**Proposed Development  
Land north east of King George V  
Playing Fields,  
Northaw Road East, Cuffley,  
Hertfordshire.**

Surface Water Flood Modelling Technical Note  
To Support Discharge of Conditions 6 & 19

### Technical Note 01: Surface Water Modelling

The following section provides direct responses against the queries raised by the LLFA objection letter (6/2023/0444/COND). Specific concerns raised are provided in *Italic* text prior to each response.

**Figure 2-1 DDF calculations FEH13.**

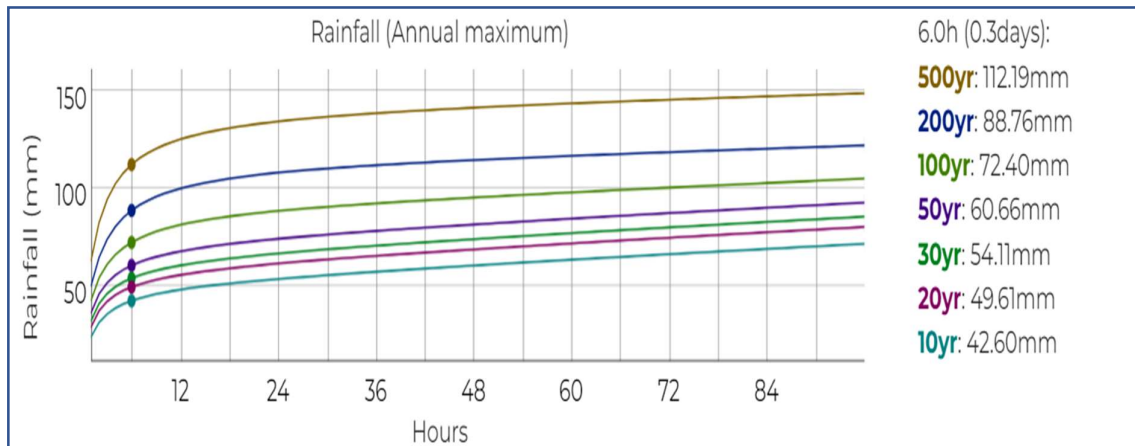
- Provide evidence as to how the storm duration values were chosen and provide evidence as to which one is defined as the critical storm duration (which would likely to be less than 6 hours).

4.11 Using the DDF curve calculations rainfall depths for design storms of 100yr and 1 in 1000yr events with durations of 1hr was obtained. **Table 2-1** in section 2 of this report shows the rainfall depths for design storms of 1 in 100yr and 1 in 1000yr events with durations of 1hr, calculated using the DDF curves in **Figure 2-1**.

**Figure 2-3 Hyetograph for 1h rainfall duration.**

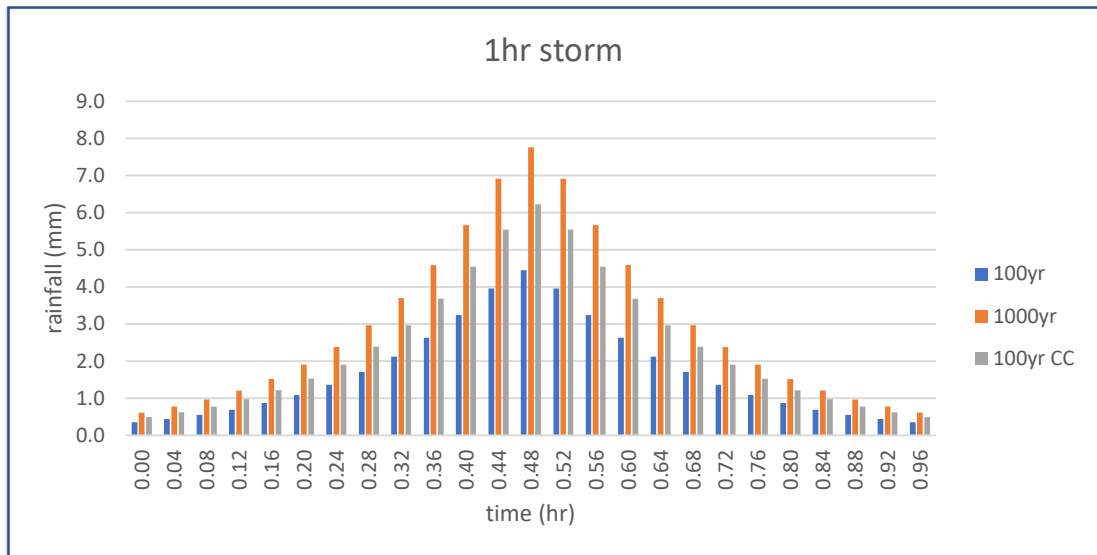
- *Provide methodology of how rainfall has been applied to the model and whether it considers permeable and impermeable areas separately. Provide clarity as to whether land uses have been separated or not.*

- 4.13** The Depth for a 1h duration and 1 in 100yr+40%CC event is shown in **Table 2-1**. Within the model this depth is used as effective rainfall for the entire sub-catchment within the 2d boundary condition (2d\_rf) at the area shown in **Figure 3-1**. The rainfall is set at the boundary condition data base (bc\_dbase) with the total depth divided in a hyetograph throughout the 1hr duration, as is shown in **Figure 2-3**.

**Figure 3-1 Updated direct rainfall area.**

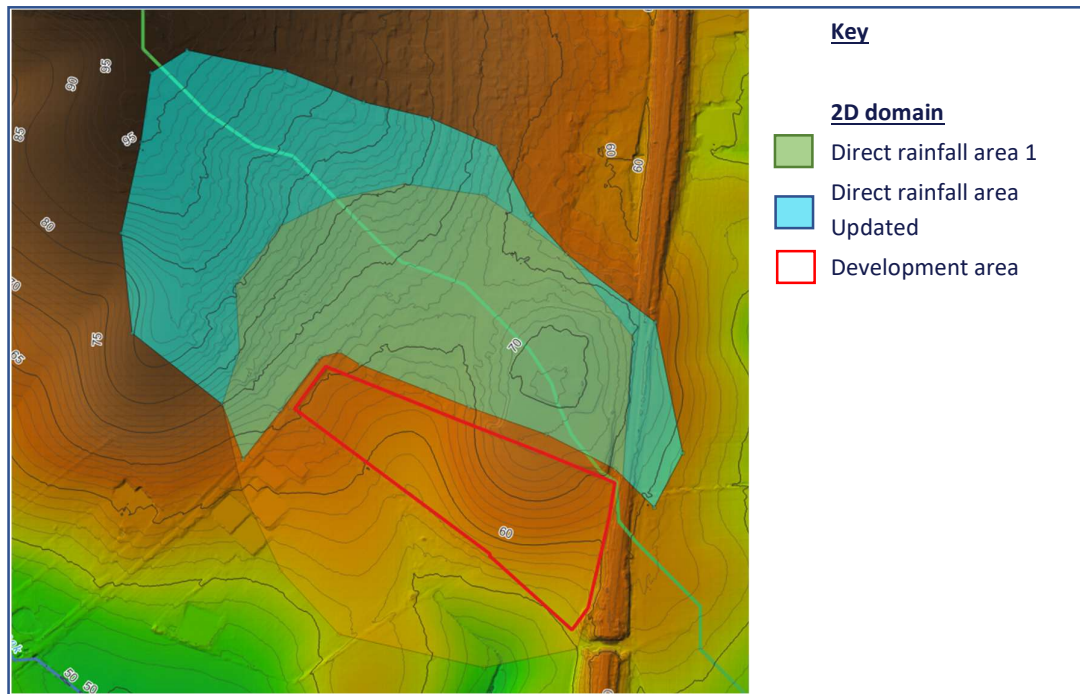
- *The rainfall catchment (polygon) for direct rainfall needs to be extended, as it does not provide an accurate representation of the full drainage catchment.*

- 4.1 As discussed in section 3.2 a detailed catchment analysis of the flow routes and flow accumulation has been undertaken since the previous modelling report.

- 4.2 In order to mitigate concerns and demonstrate the direct rainfall region has been modified, **Figure 3-1** has been provided. This demonstrates increases in the upper catchment section, which will generate the potential for additional flow accessing the site from the north and west boundaries.

Figure 4-1 Railway underpass

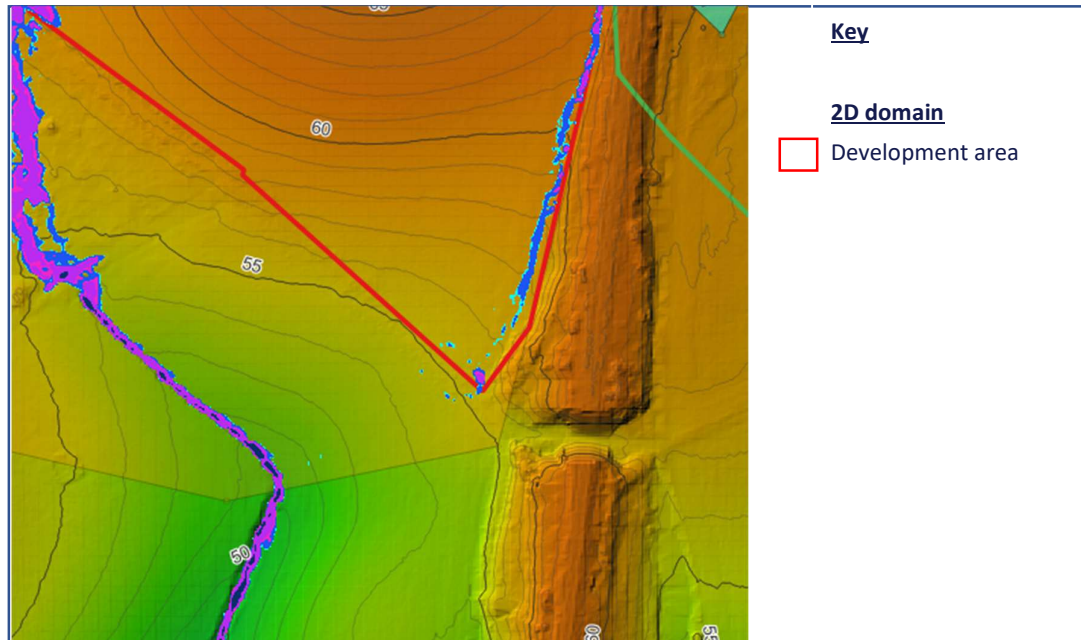
- *Confirmation as to whether the railway underpass at the south-east extend of the site has been modelled, as this could potentially alter flow paths or downstream boundary.*

- 4.4 The railway underpass to the south-east section of the site has been included within the digital elevation model of the proposed development site as demonstrated in **Figure 4-1** below. The underpass is defined as a pedestrian route originating and Northaw Rd to the West of the development site and extending to the west where it meets Burntfarm Ride. The topography shows the cut under the railway line at the underpass location, however, Baseline and Development modelling scenarios does not show any flow traces in the direction of the underpass.

- 4.5 The main flow route is via Northaw Brook which extends further to the south of the site before crossing beneath the railway line at the Sopers Farm Viaduct.

- 4.6 **Figure 4-1** illustrates the baseline scenario and the natural flow path parallel to the railway line. The railway underpass and pedestrian pass is not affected.

**Figure 4-2** Maximum flood depth Surface water, 1h duration 1 in 1000yr

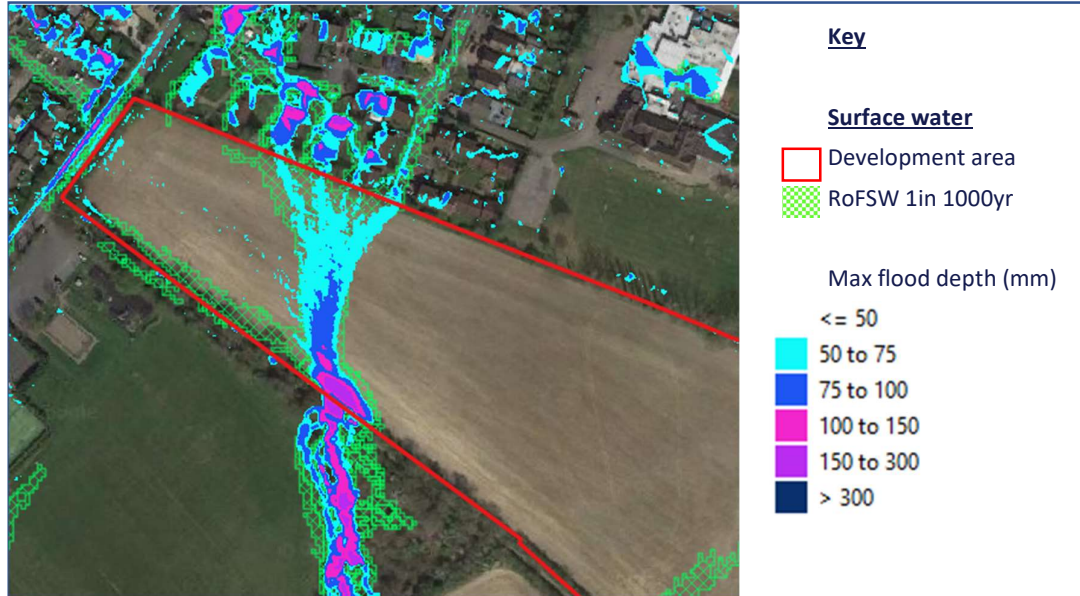
- Provide comparison of EA surface water maps alongside the surface model baseline scenario. Surface water flooding depth difference maps between pre and post development should be provided to illustrate comparisons to help verify results and identify where flood risk is reduced or increased. Appropriate key levels should be included.

**4.20** Figure 4-2 shows the existing baseline scenario, for a 1 in 1000yr event, 1h rainfall duration.

- 4.22 The baseline scenario represents the as existing condition and shows the current flood risk at the development area without any changes in ground levels or any surface water drainage systems implemented on the development site. Figure 4-2 and 4-3 demonstrate good correlation between the EA RoFSW and our baseline models.
